SP2019-035

Kwik Kar

Job Address: 2581 HORIZON RD

SP2019-35; Site Plan for Kwik Kar

KWIK KAR ROCKWALL, TEXAS Scale: 1'' = 20' - 0''MM/DD/YEAR Project No.: AAAAAA

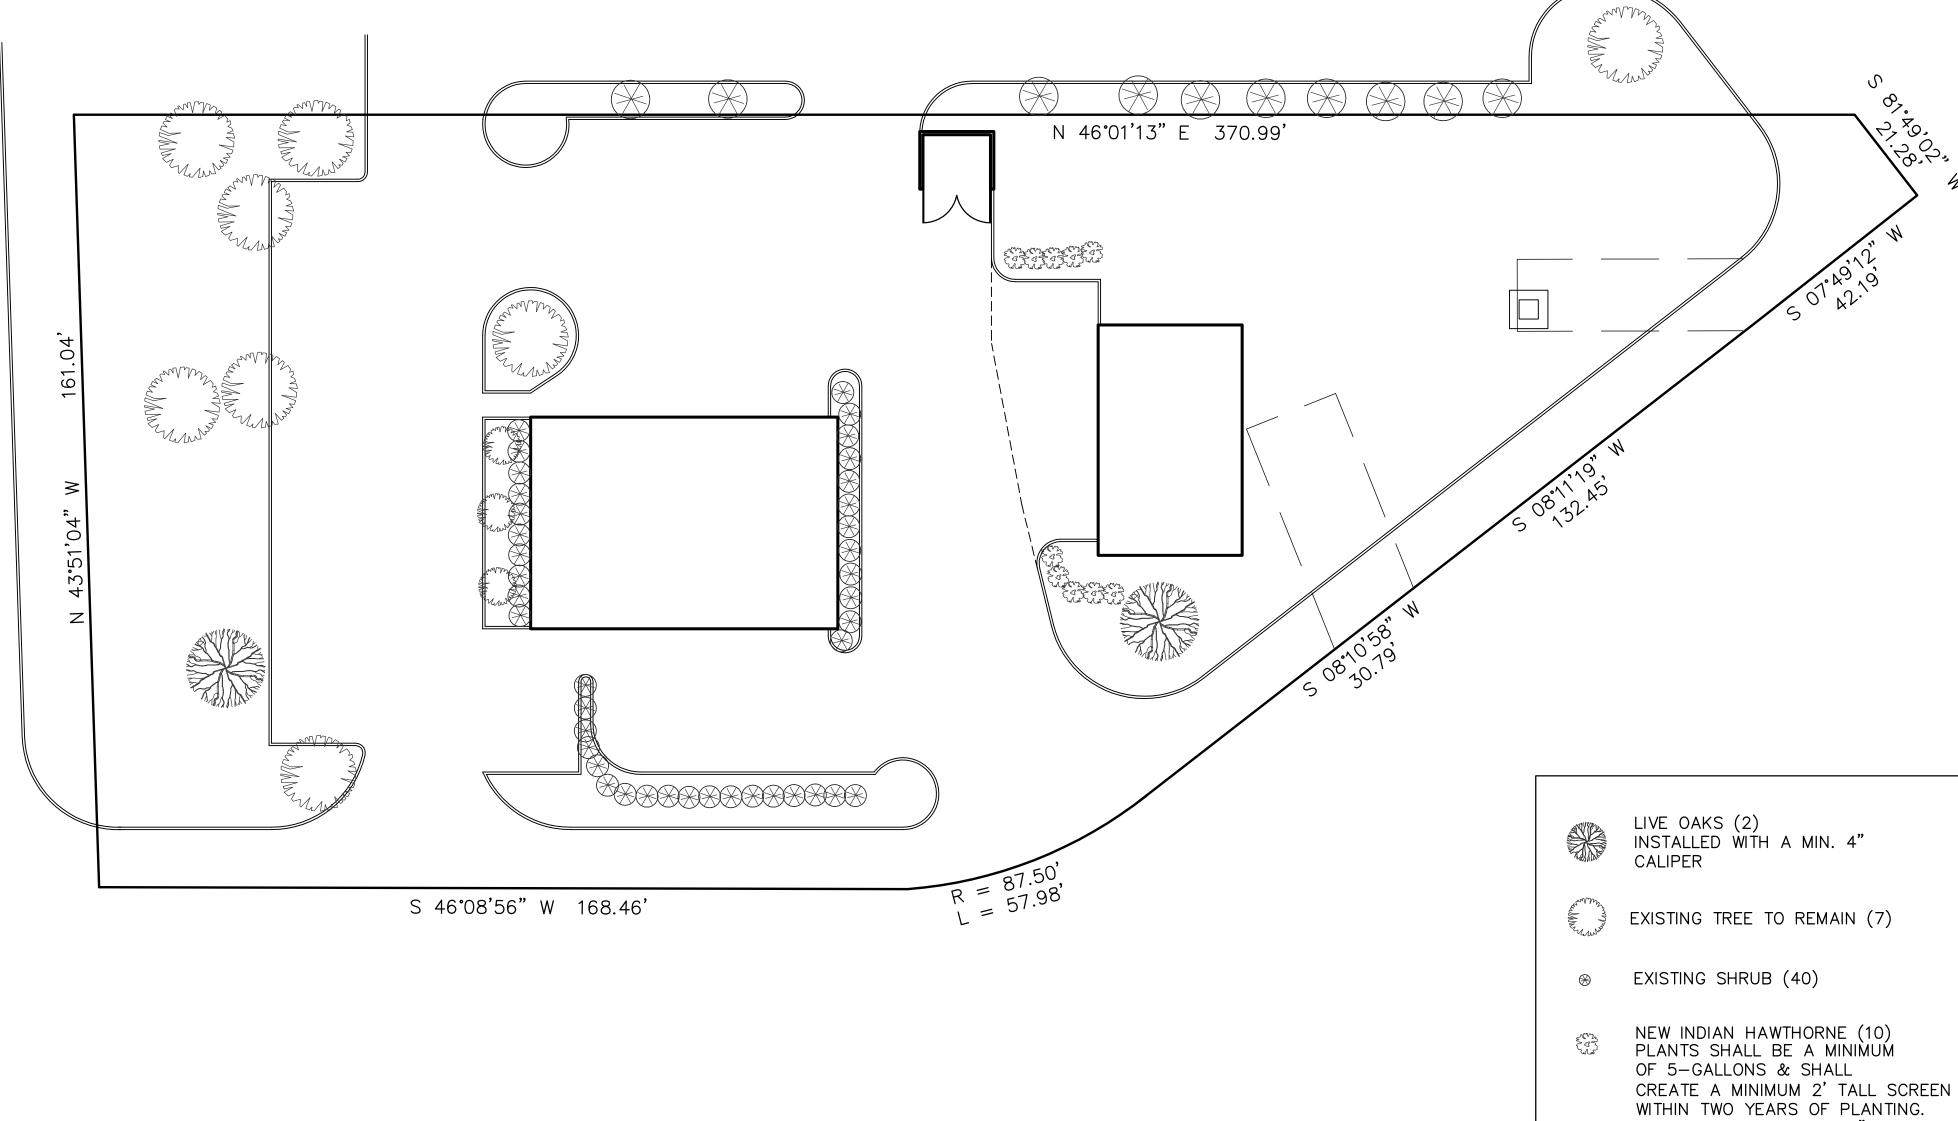
- M.18 Please greyscale all existing pavement, buildings, etc.
- M.19 Please show utilities and easements.
- M.20 Please dimension typical parking space. Is any new parking being added?
- M.21 Please label property line.
- M.22 Please show firelane.
- M.23 Please dimension all drive aisles.
- M.24 Please differentiate existing/proposed on the site data table.
- M.25 Please show centerline of Horizon Road.
- M.26 Please show and label front setback and landscape buffer.
- M.27 Please show actual footprint of new building.
- M.28 Please show and label adjacent properties.

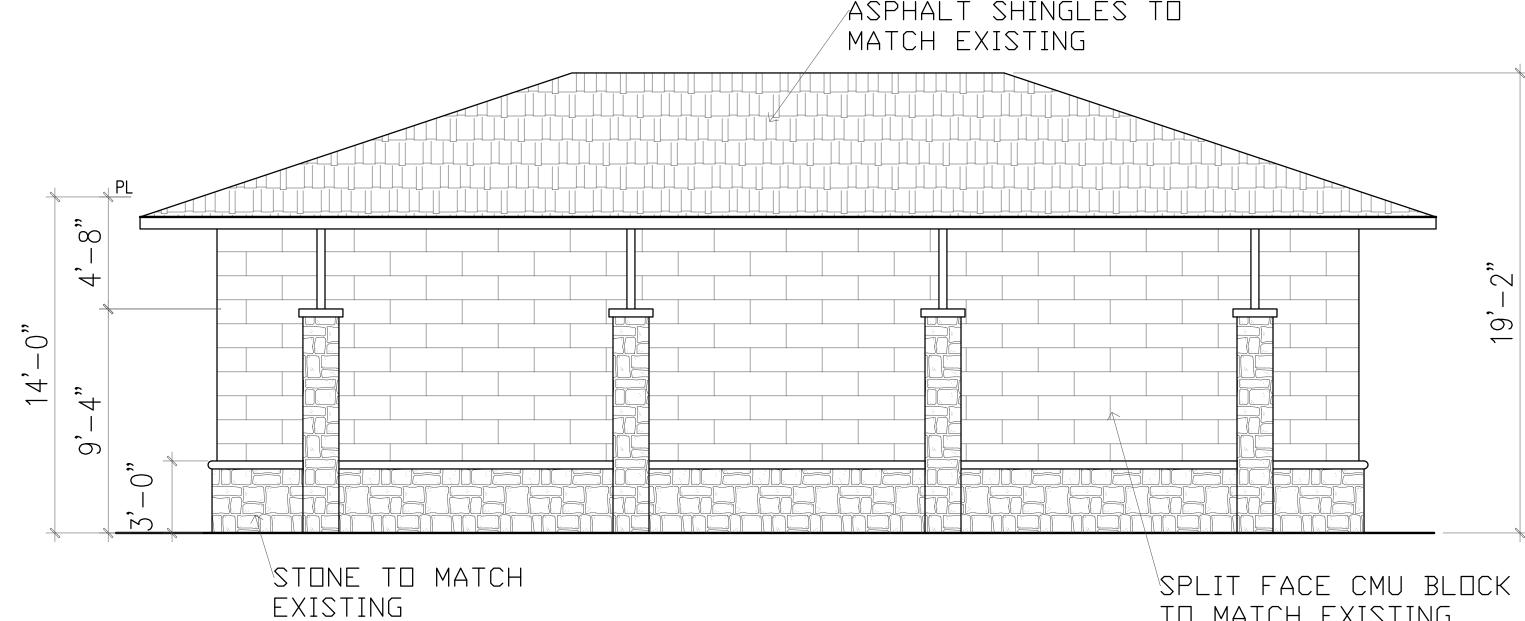
- M.29 Please label the property line
- M.30 Please show and label adjacent properties.
- M.31 Please provide vicinity map.
- M.32 Please provide site data table.
- M.33 Please note, the landscape % for Commercial (C) District is 25% as show above.
- M.34 Please same items as site plan such as parking, utilities, etc. and greyscale.
- M.35 Please note hydromulch is not allowed in ROW landscaping.
- M.36 Please note, the property line adjacent to Horizon Road appears to be off scale. Please check scale.

- M.37 Please show and label the 10-foot landscape buffer adjacent to Horizon Road
- I.38 Please note that failure to address all comments provided by staff by5:00 PM on October 1, 2019 will result in the automatic denial of the case on the grounds of an incomplete submittal. No refund will be given for cases that are denied due to an incomplete submittal and a new application and fee will be required to resubmit the case.

NORTH ELEVATION **100% MASONRY 30% STONE 70% BLOCK**

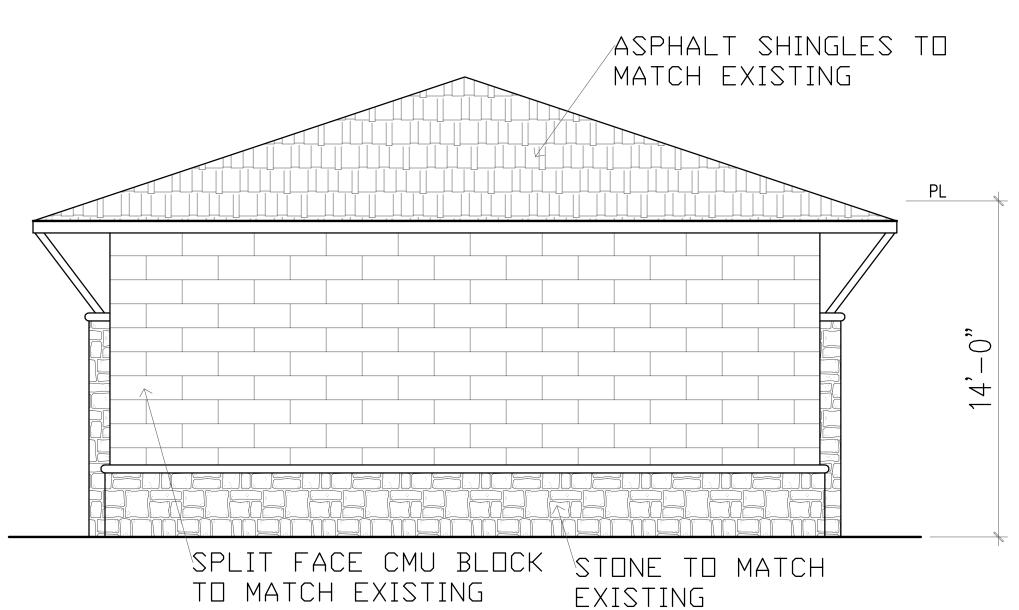
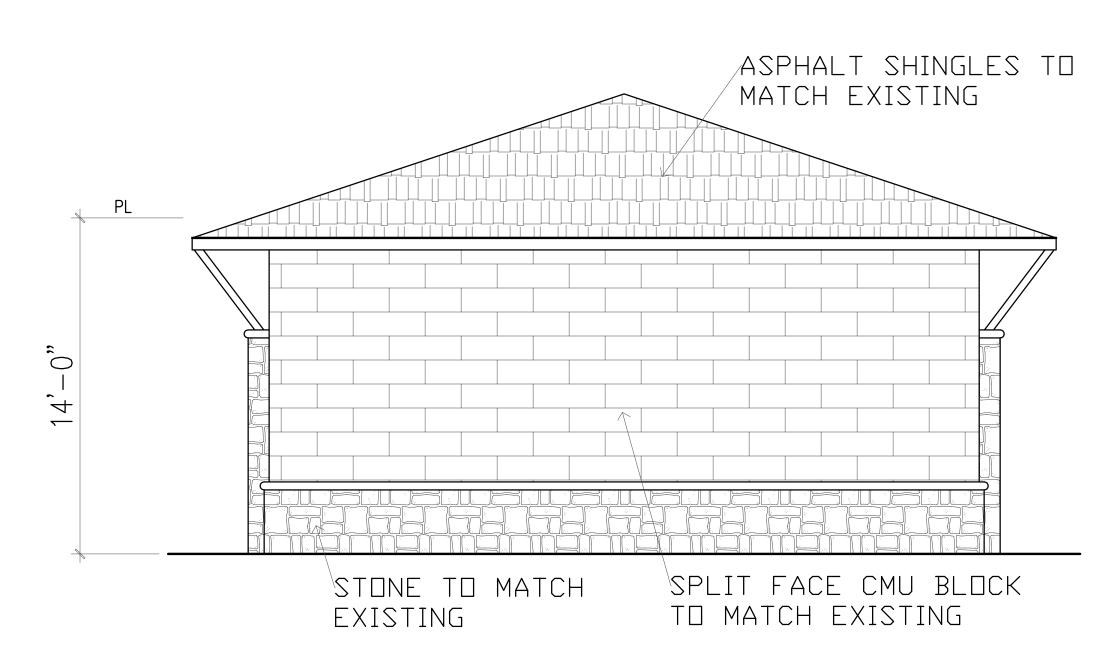
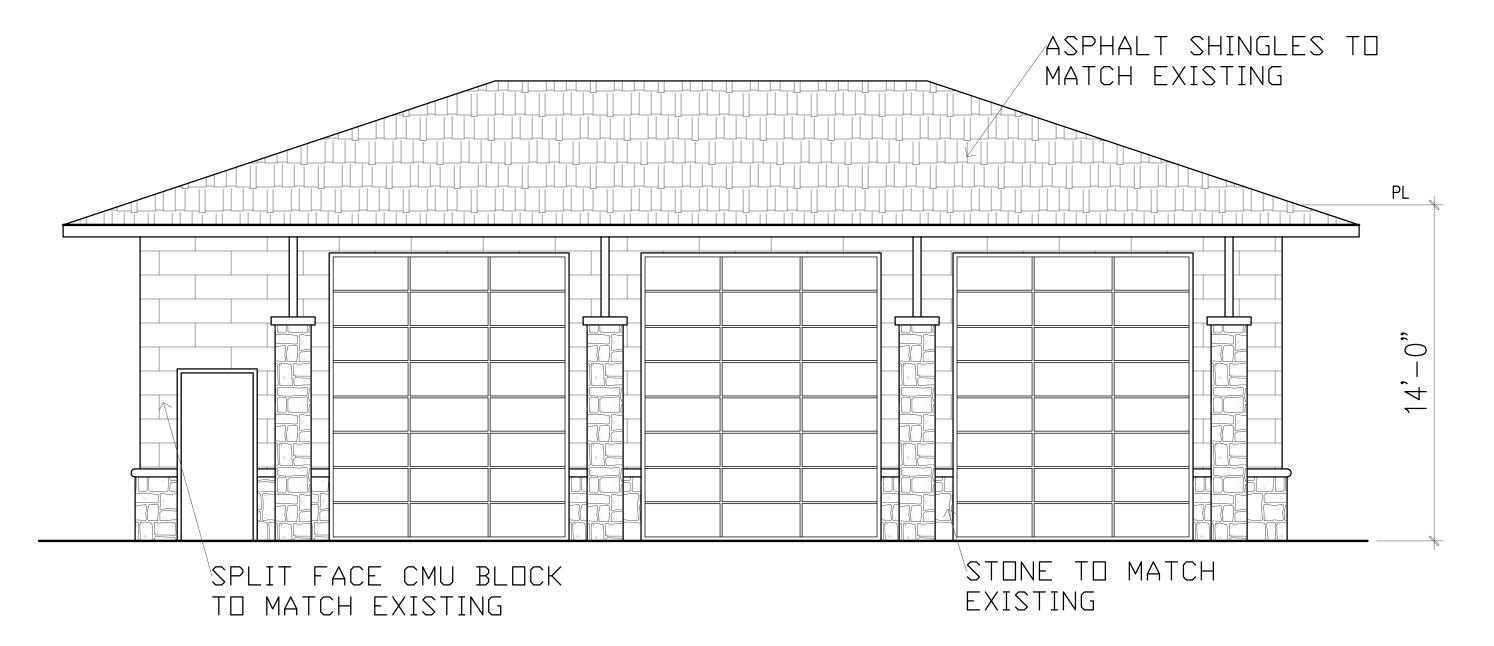
- (C) Building Articulation.
- (1) Primary Building Façades. A primary building façade is any building façade that has a primary entryway for a business or that has an adjacency to a public right-of-way, open space/green space, public/private park, and/or a residential zoning district or residentially used property. All commercial buildings shall meet the following standards for articulation on primary building façades

- Wall Length. The maximum wall length shall not exceed three (3) times the wall height without a secondary entryway/architectural element
- Secondary Entryway/Architectural Element Length. The minimum length of the secondary entryway or projecting architectural element shall be 25% of the wall length

- Wall Projection. The minimum wall projection for a primary and/or secondary entryway/architectural element shall be 25% of the wall height
- Primary and/or Secondary Entryway/Architectural Element Width. The minimum width of the primary and/or secondary entryway/architectural element shall extend for twice the required wall projection

- Projection Height. The primary and secondary entryways/architectural element shall extend a minimum of 25% of the wall height above the top of the wall

- Primary Entryway/Architectural Element Length. The primary entryway/architectural element shall meet all of the same projections as the secondary entryway/architectural element, but shall extend for a minimum of twice the length of the secondary element. Currently, you will need an exception to the building articulation standards for the front and the rear facades.
